# A d d e n d u m

Iowa Department of Transportation  
Office of Contracts

Date of Letting: March 17, 2015  
Date of Addendum: February 27, 2015

<b>B.O.</b>	<b>Proposal ID</b>	<b>Proposal Work Type</b>	<b>County</b>	<b>Project Number</b>	<b>Addendum</b>
353	78-0801-452	ITS EQUIPMENT	POTTAWATTAMIE	IMN-080-1(452)1--0E-78	17MAR353.A01

ITS QUANTITIES

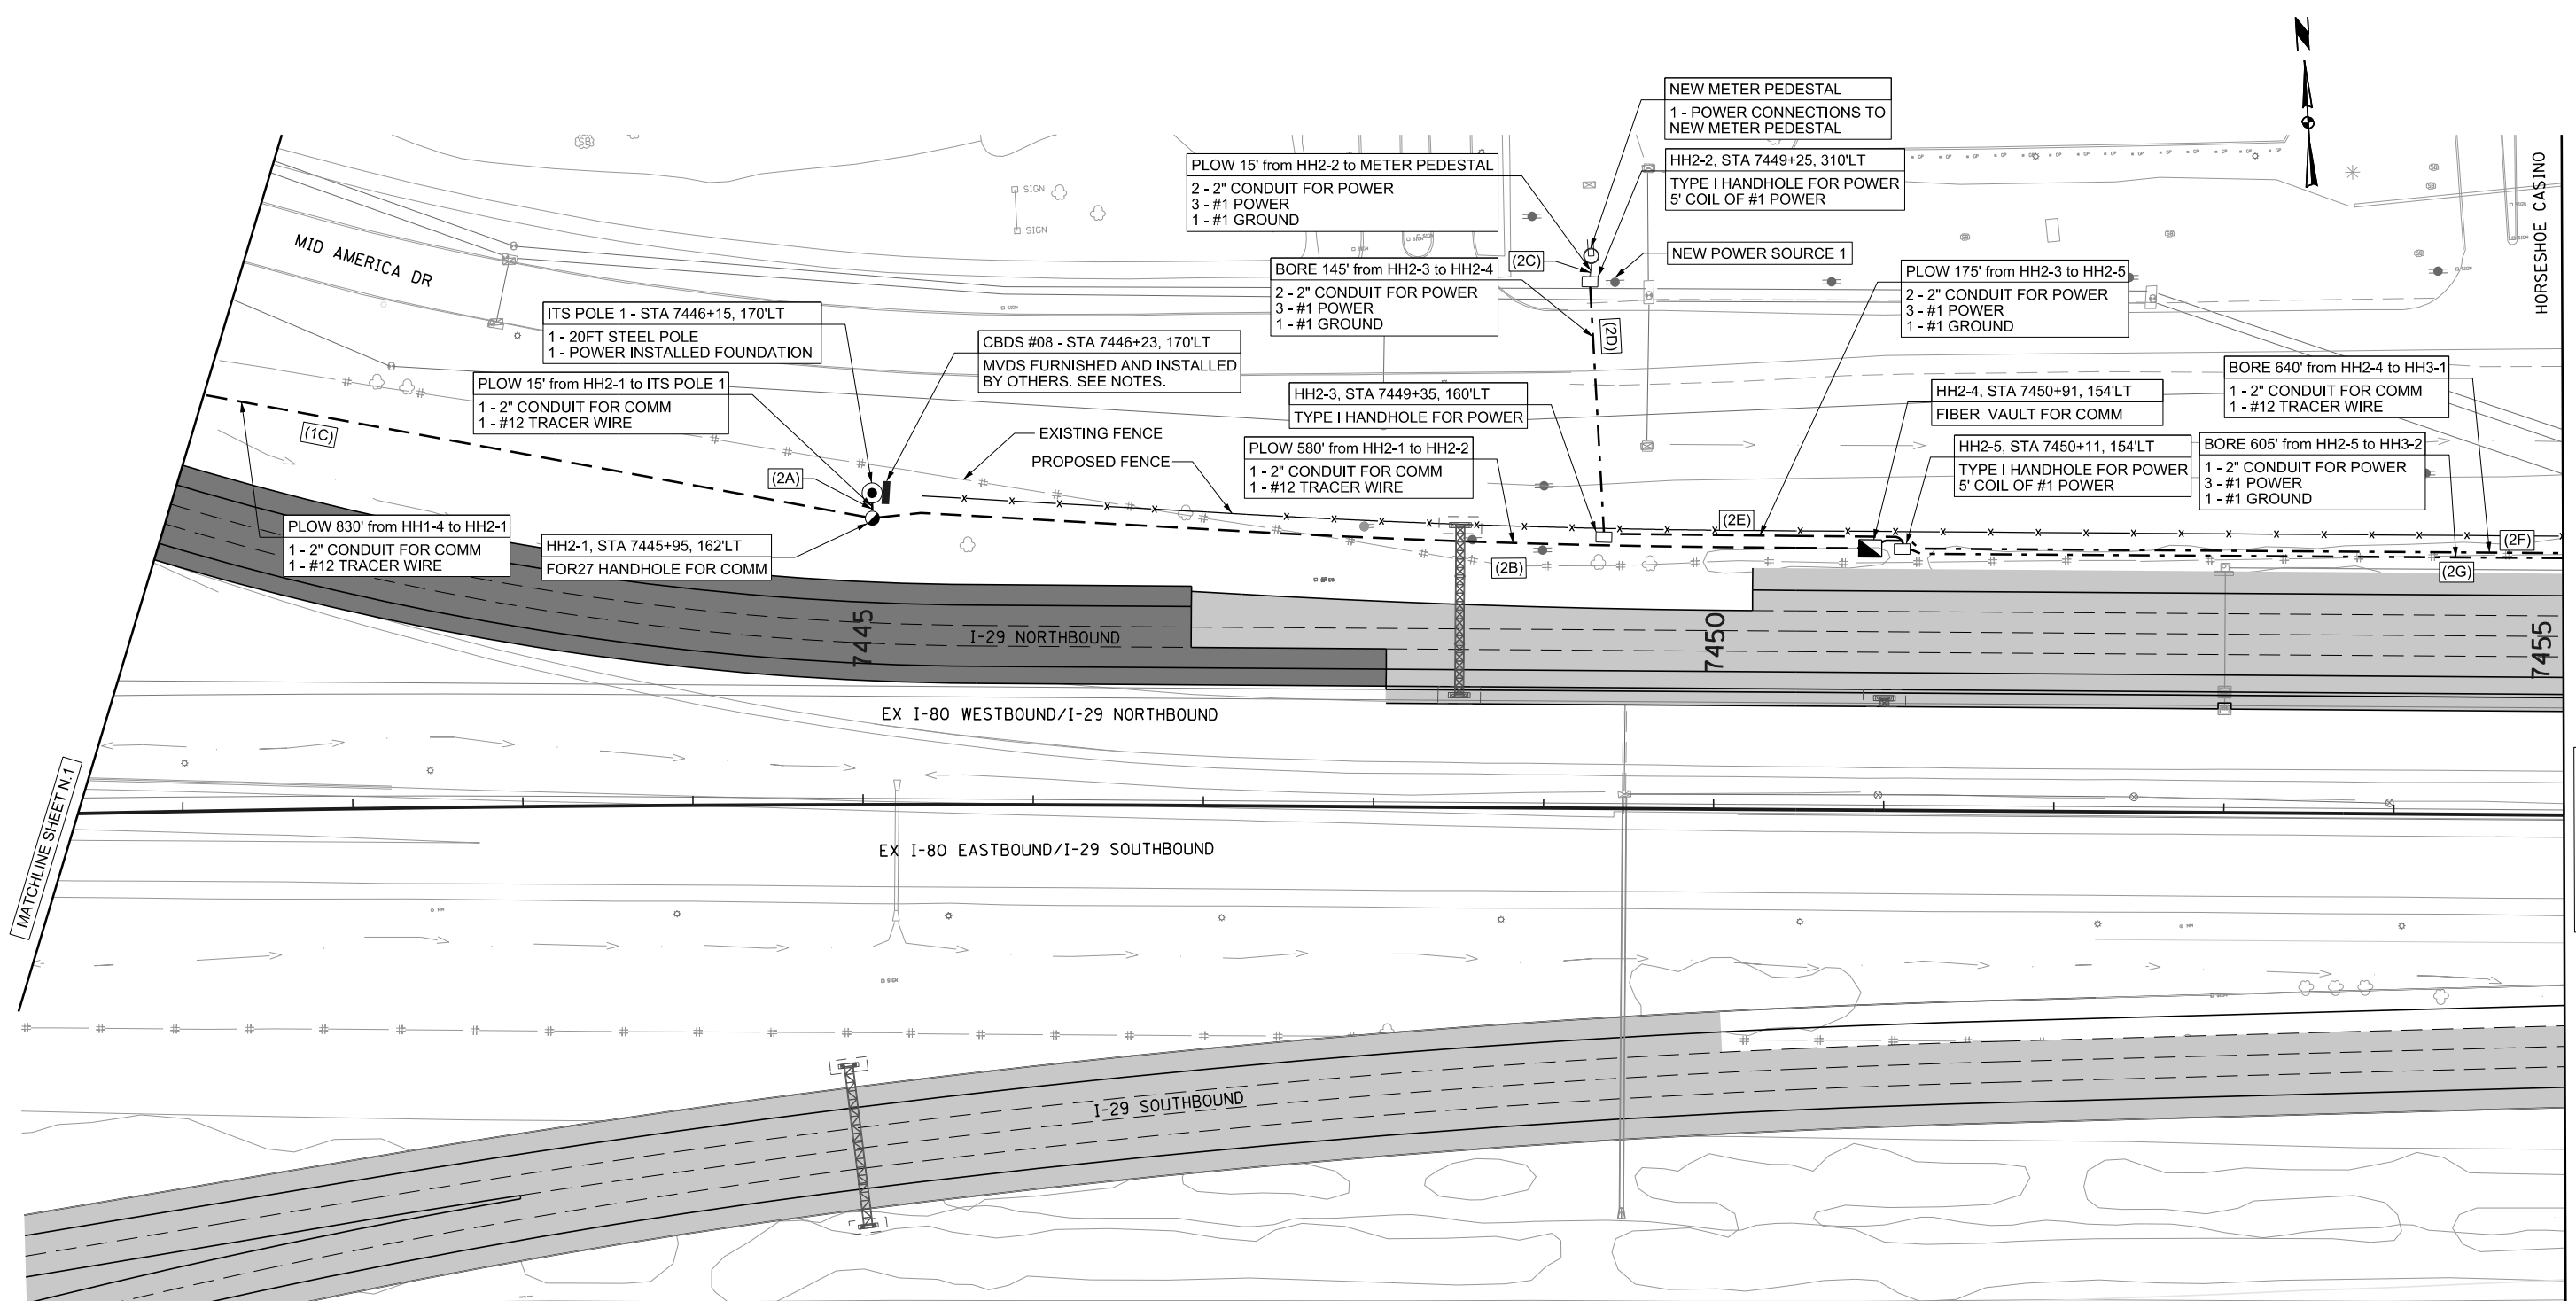
- Replace Sheet C.2 with attached sheet C.2
  - Replaced #4 power quantities with #2 power
  - Updated 2" Conduit locations to reflect the addition of an extra 2" conduit to account for future cables. They have been added to conduit runs 2C, 2D, 2E, 6A and 6B

ITS PLAN

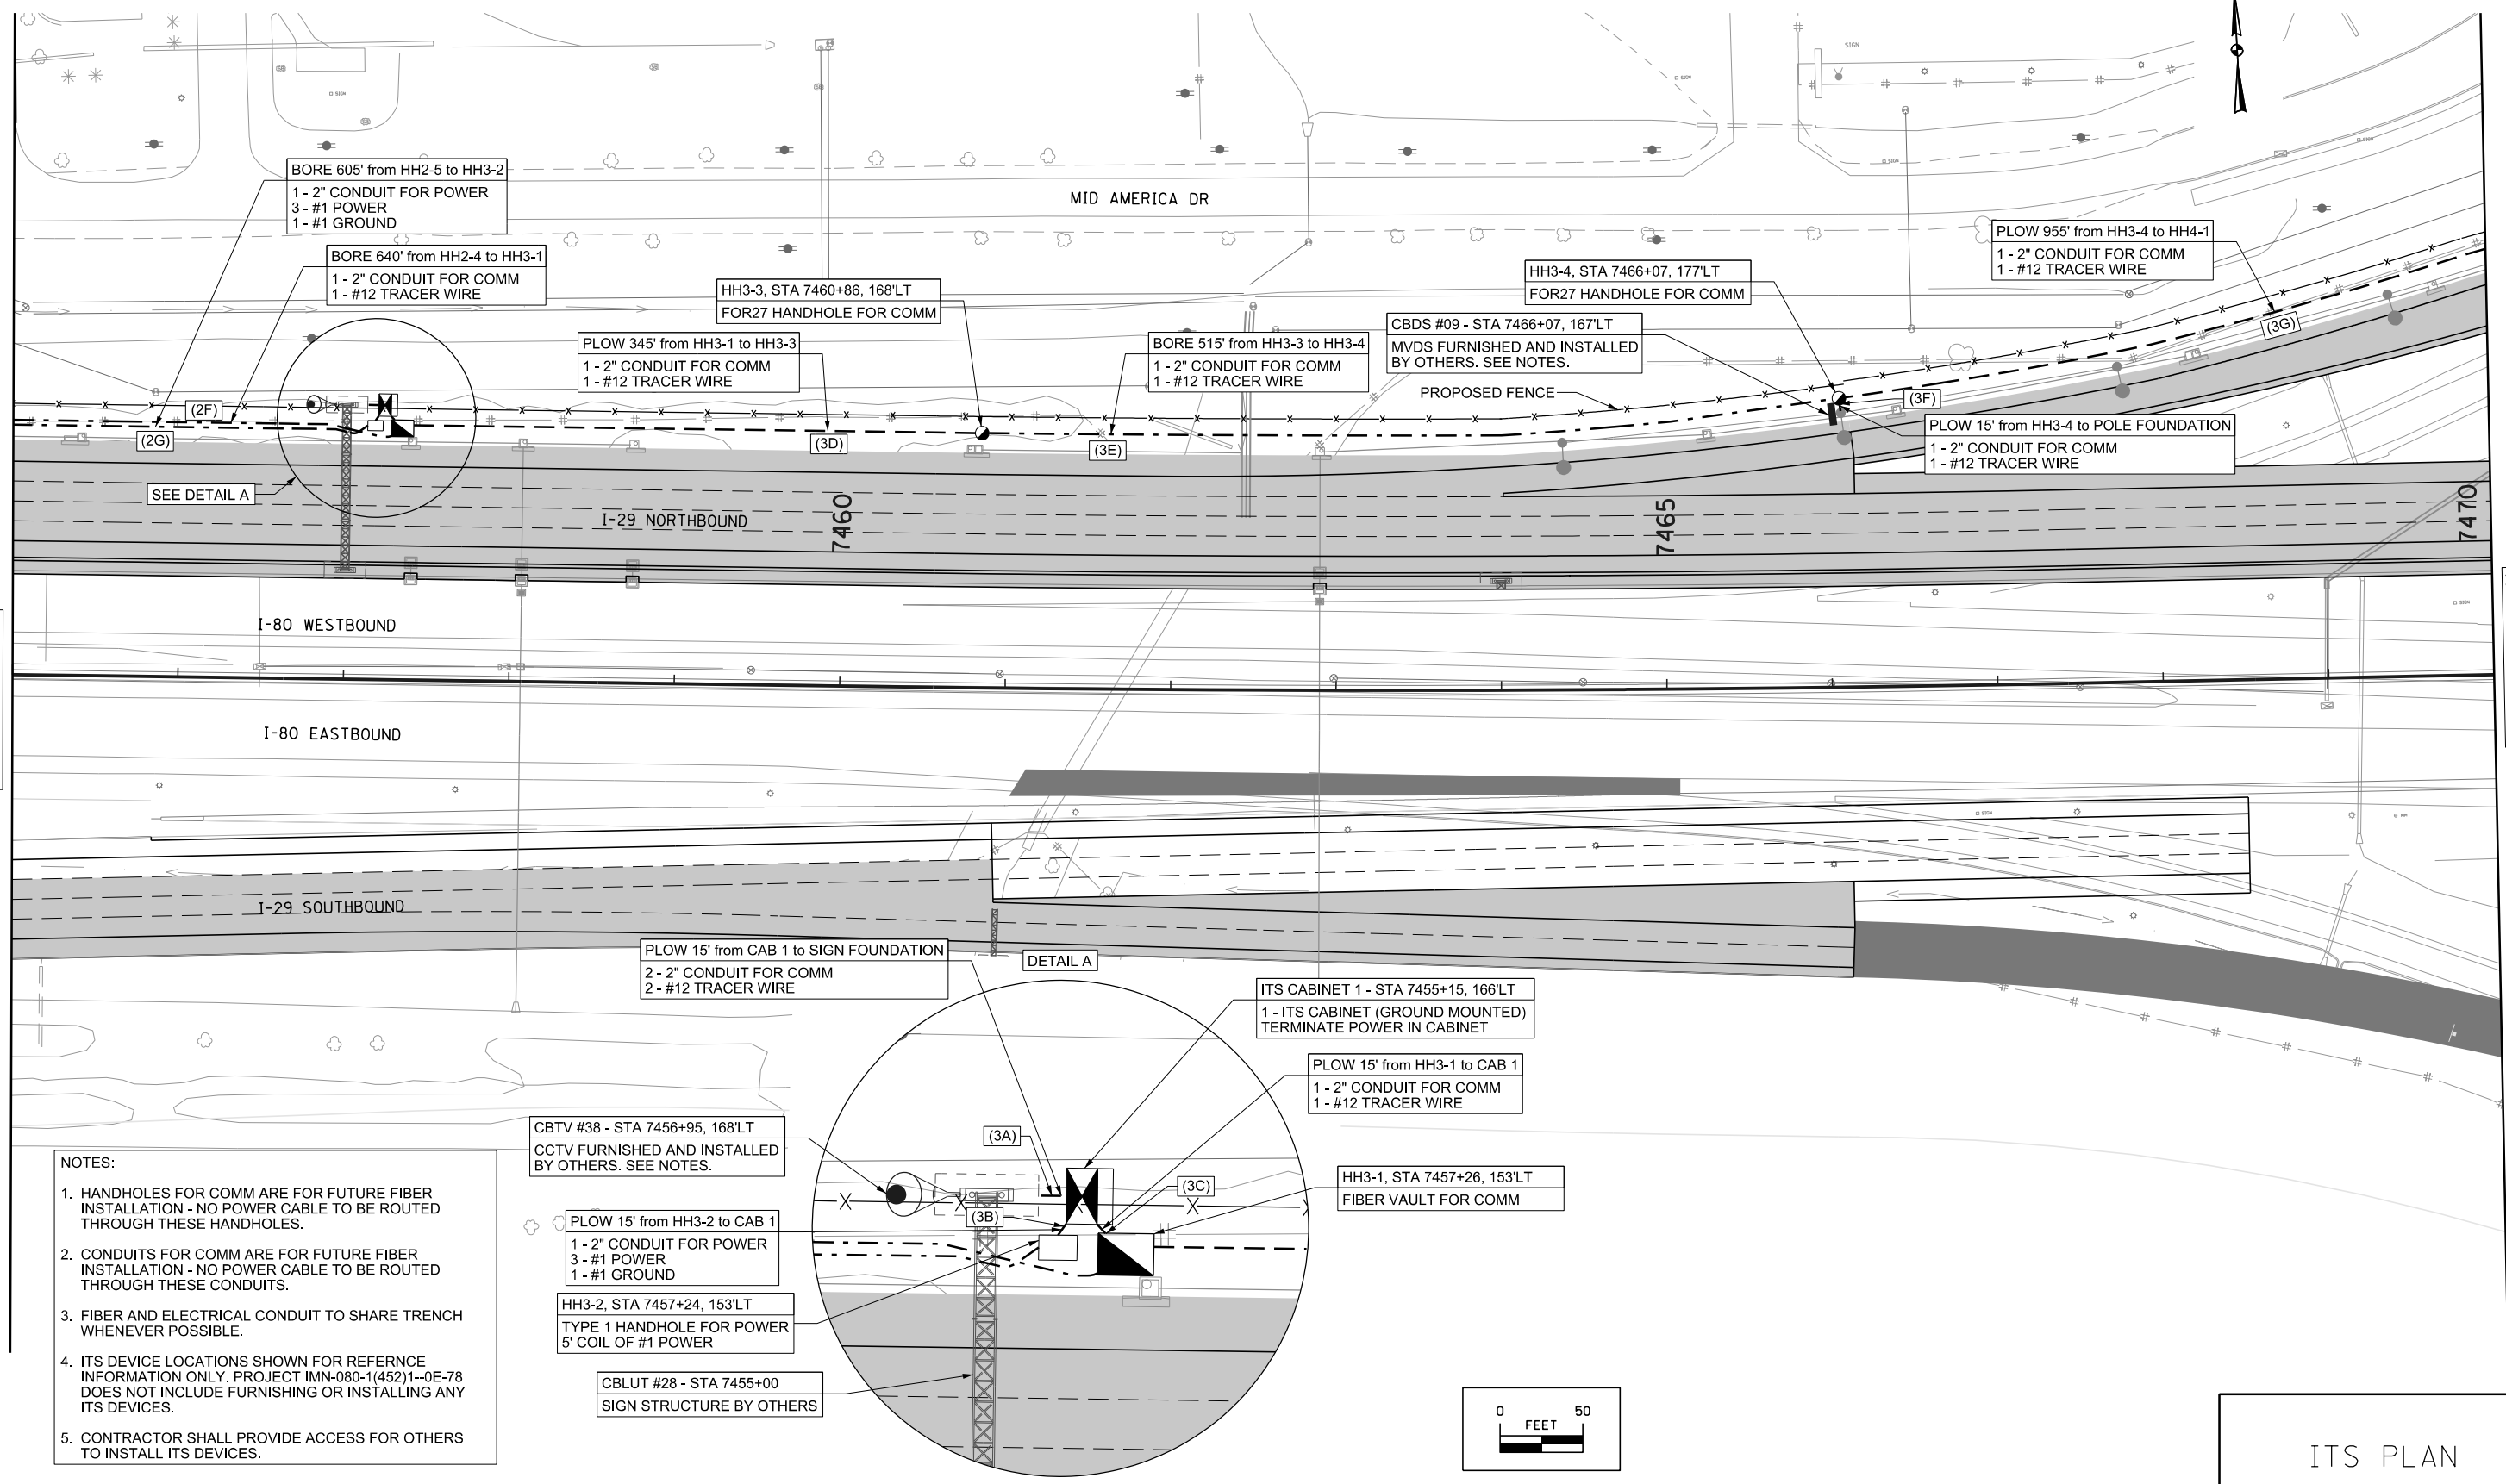
- Removed #4 Power from ERI
- Replace Sheet N.2 with attached sheet N.2
  - Based on electrical discussion, power needs include 3-#1 Power and 1-#1 Ground (see conduit runs 2C, 2D, 2E & 2G)

- To account for future power cables, an additional conduit has been added to conduit runs 2C, 2D, and 2E
- Replace Sheet N.3 with attached sheet N.3
  - Based on electrical discussion, power needs include 3-#1 Power and 1-#1 Ground (see conduit runs 2G & 3B)

ITS PLAN

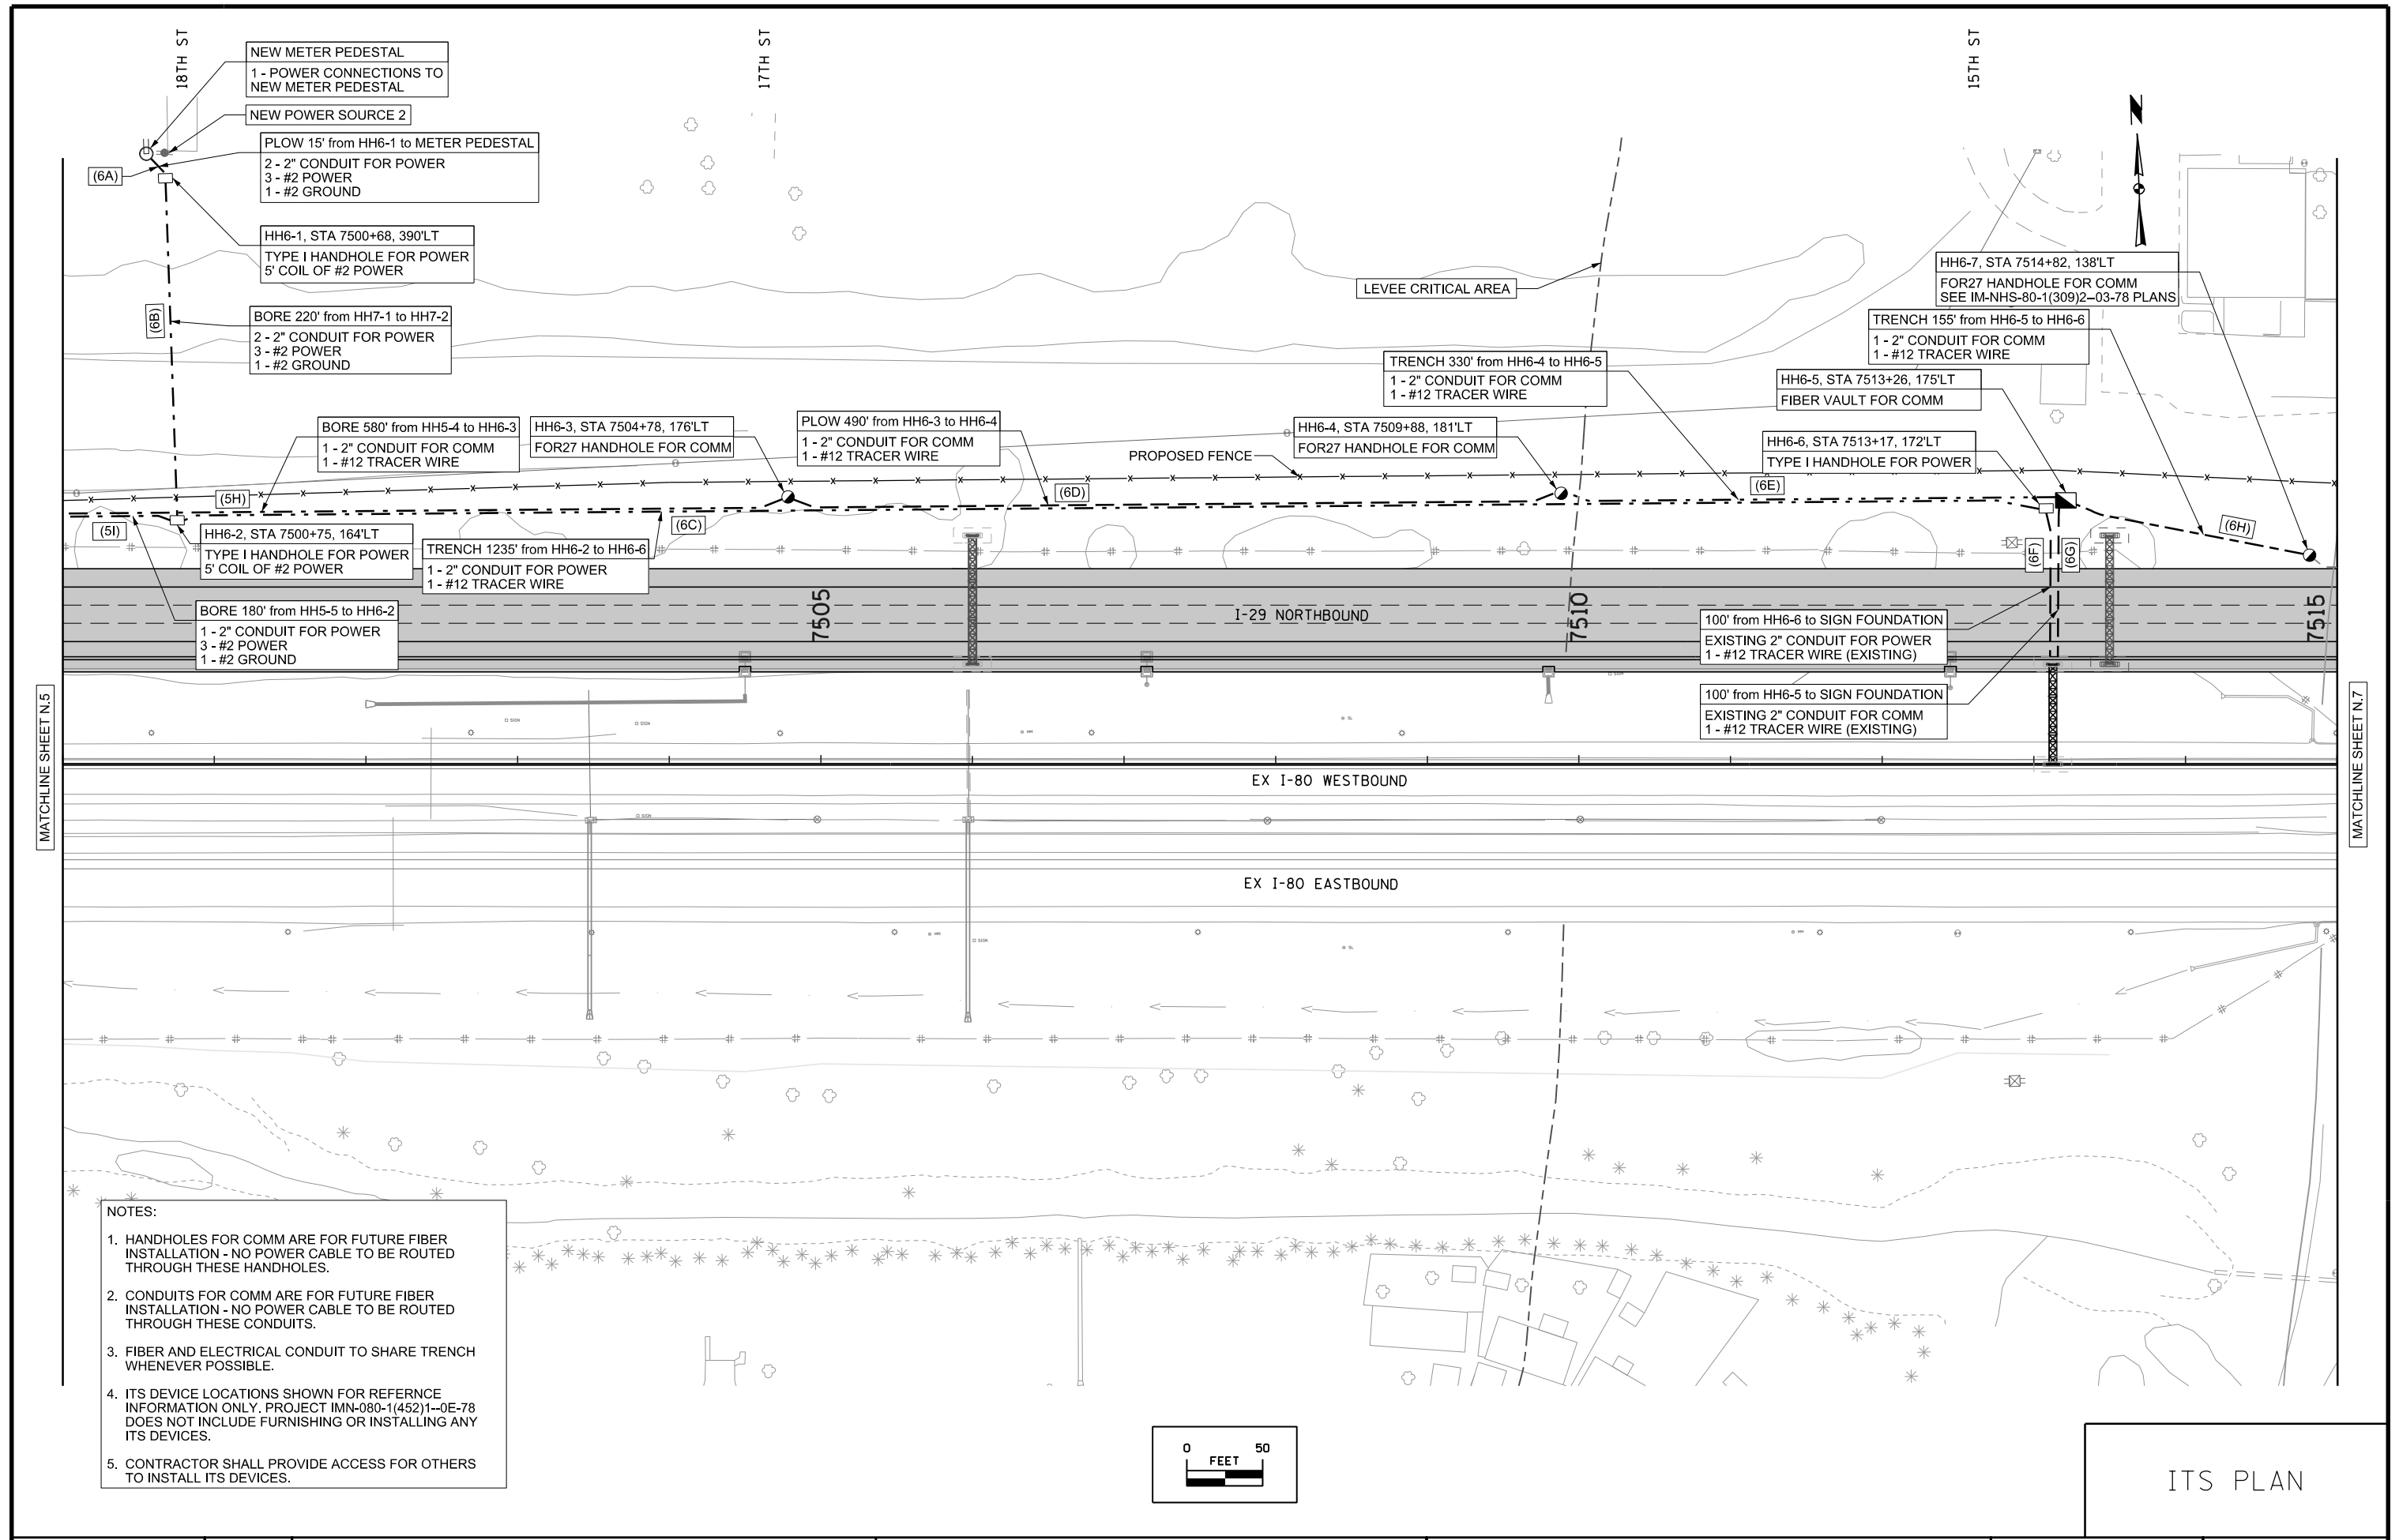
- Replace Sheet N.5 with attached sheet N.5
  - Based on electrical discussion, power needs include 3-#2 Power and 1-#2 Ground (see conduit runs 5I & 5F)
